Groundwater Application Review Summary Form

Application # G- 18747

To: Kristopher Byrd, Well Construction and Compliance Section Manager
From: Joel Jeffery, Well Construction Program Coordinator
Subject: Review of Water Right Application G-18747
Date: June 10, 2019

TO: Water Rights Section Date 6/7/2019
 FROM: Groundwater Section Michael Thoma
 Reviewer's Name
 SUBJECT: Application G- 18747 Supersedes review of _____
 Date of Review(s) _____

Water-Level Trends in Nearby Wells

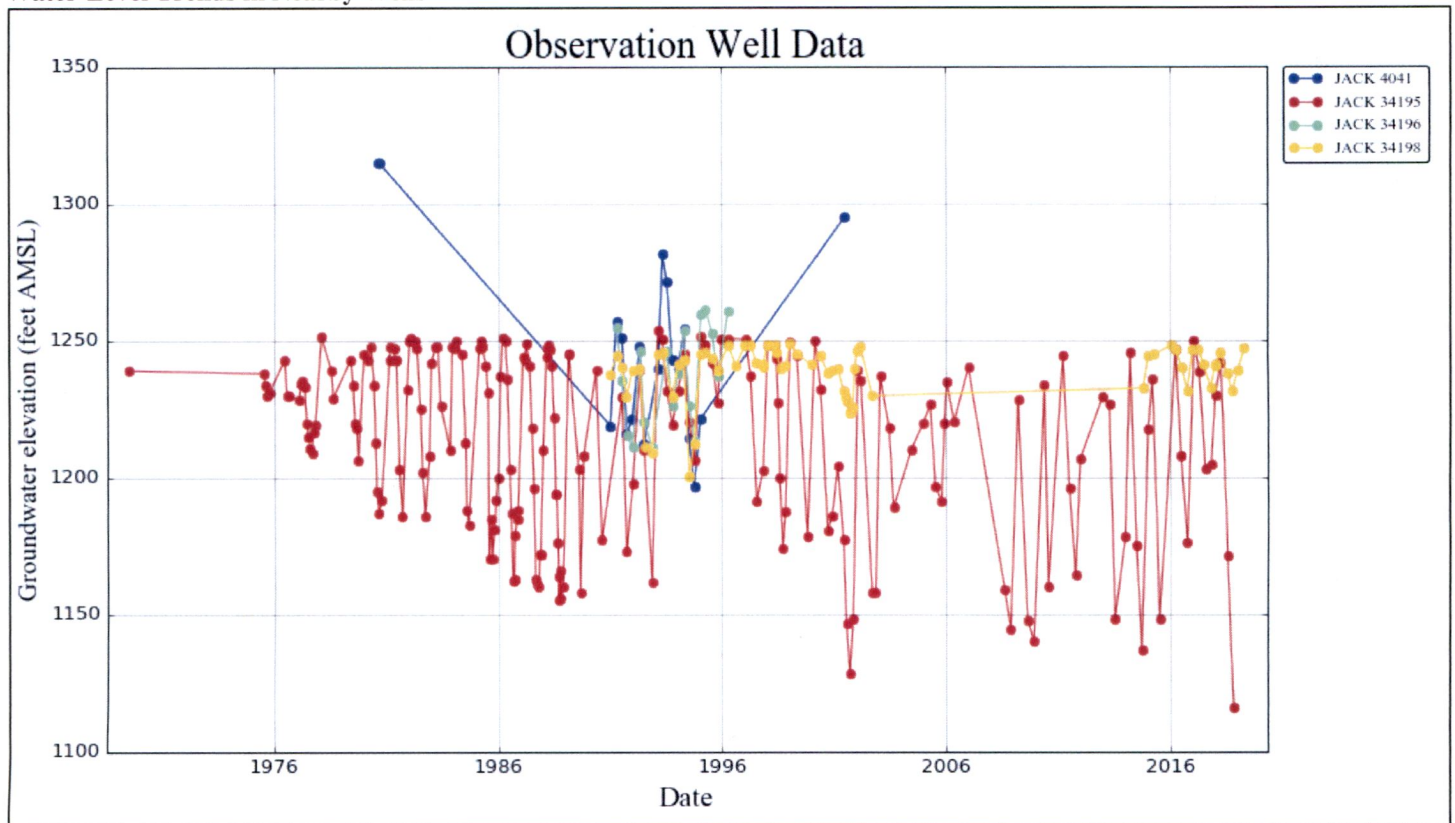
- B3. **Groundwater availability remarks:** There is one nearby OWRD Obs. Well (JACK 34198) less than ½ mile from the proposed POA that reports a stable long-term water-level trend but otherwise there are limited water level data in the aquifer and vicinity of the applicant's proposed POA so Capacity of the Resource cannot be determined and water-level reporting conditions in B1(d) are recommended. There are three permitted groundwater rights within 1 mile of the applicant's proposed POA but none are within ¼ mile. Given the generally low transmissivity of the aquifer and low rate of appropriation proposed on this application (~5 gpm), it is unlikely that the applicant's use would result in injury to these permitted water rights. However, standard interference conditions should be applied
